**Organisations: Antigua St Cycleway** To be heard

Spokes Submission to CCC on Antigua Street cycle improvements

### Antigua Street cycle improvements – feedback by Paul Mollard

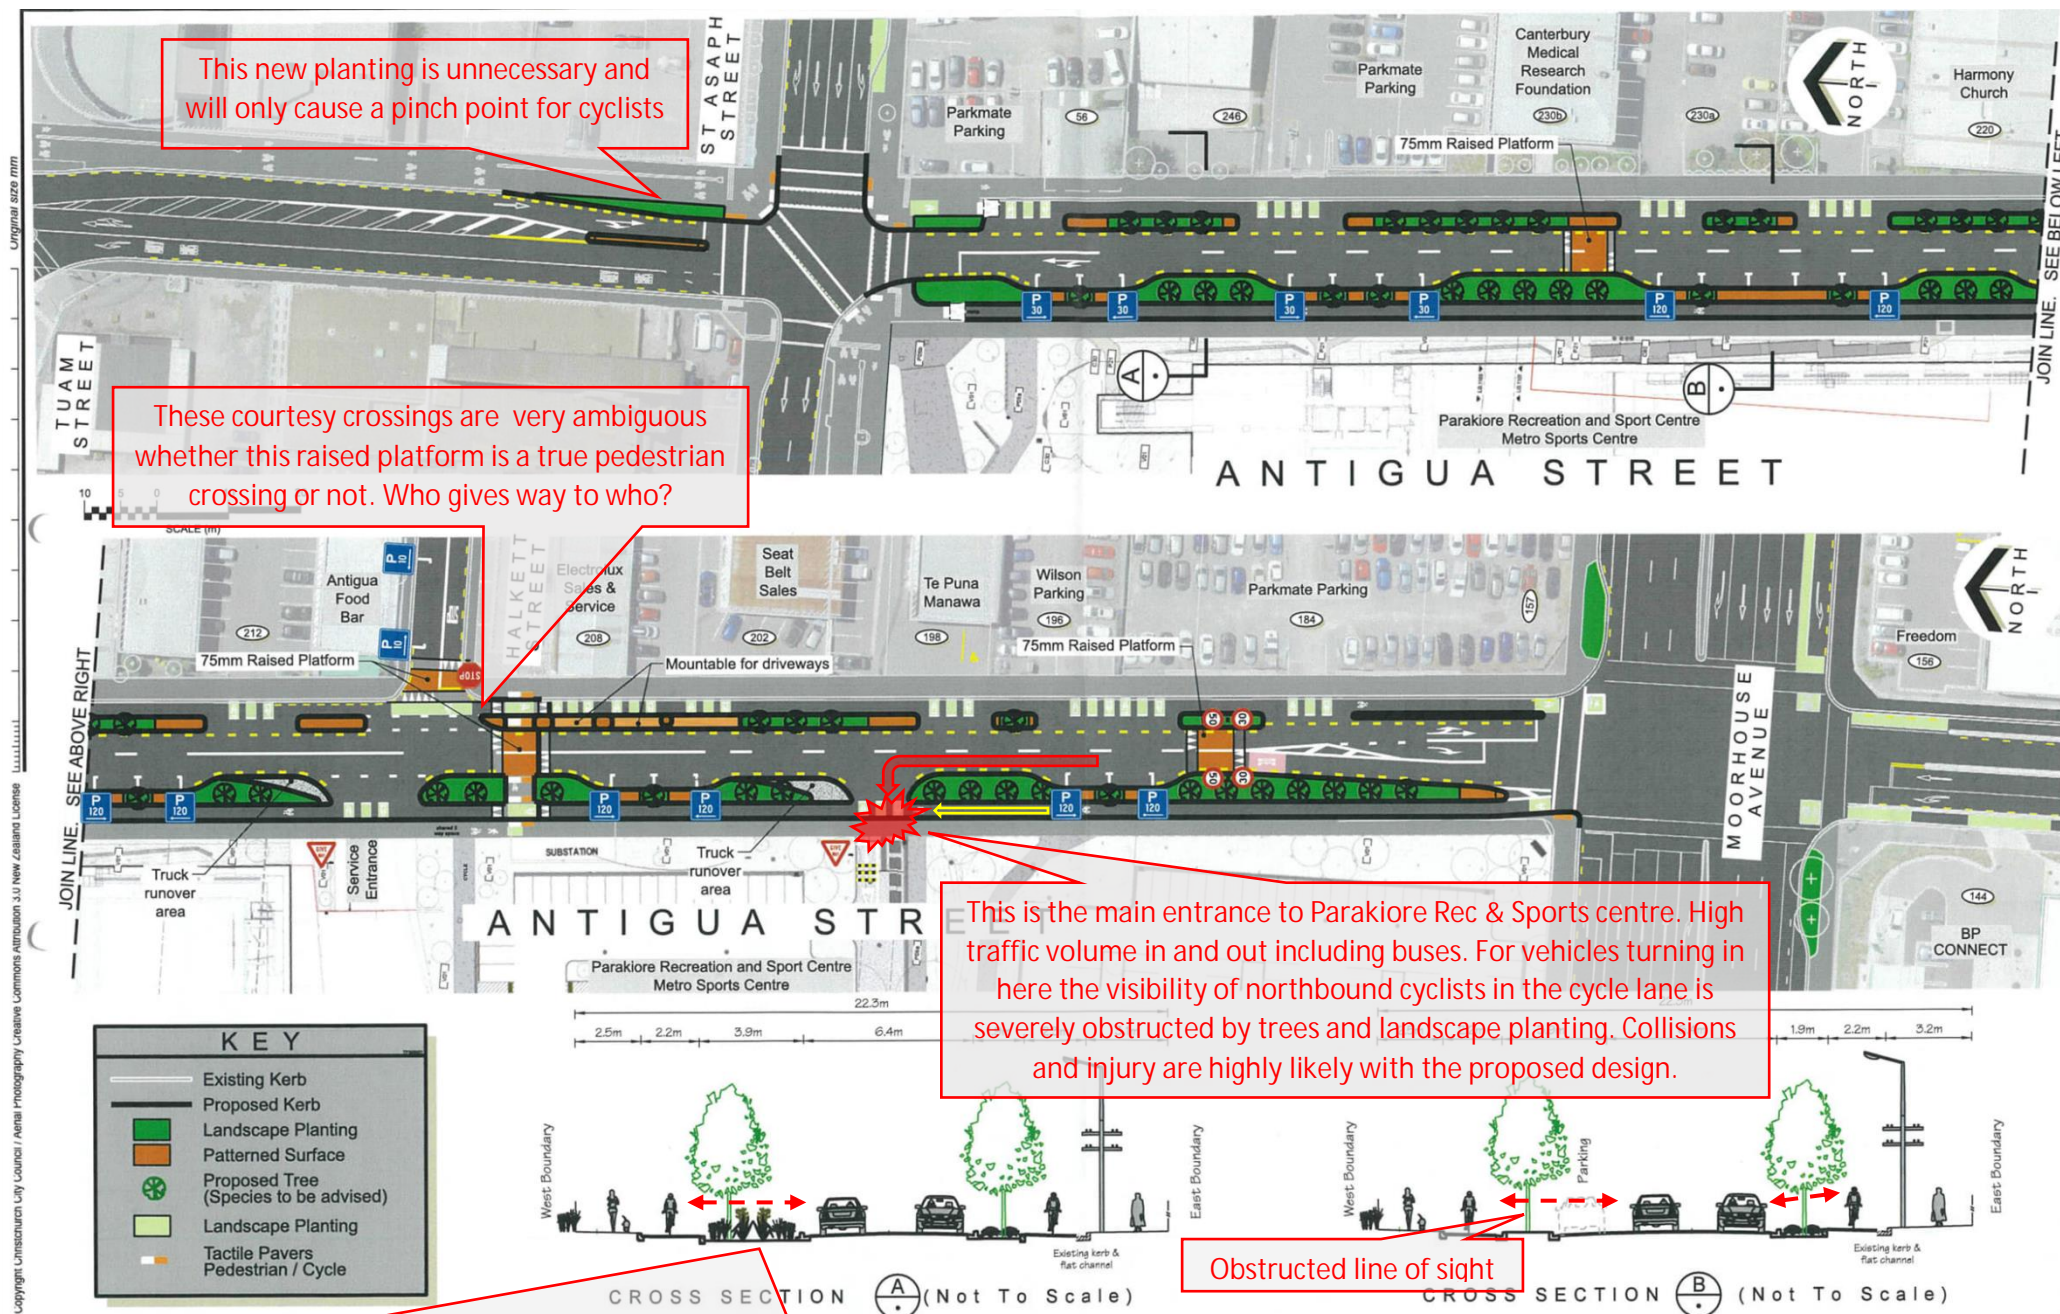
The photo below is of Tuam St on the north side of the Parakiore Sports and Recreation centre. The youtube animation shows that the planting and trees are the same style on both roads. Consider if a bus or truck was turning left across this cycle lane where would its rear vision mirrors be and how much visibility would the driver have to be able to see cyclists?

In terms of a better design you don't need to come up with something new. Strickland street is actually a good template to copy since it satisfies both the space and visibility criteria:

- No on street parking (there is lots of off street parking along Antigua St so a few on-street parks won't make any difference)
- Small concrete dividers and green painted lanes
- Some trees on the grass verge between the footpath and the cycleway but not too near to intersections.
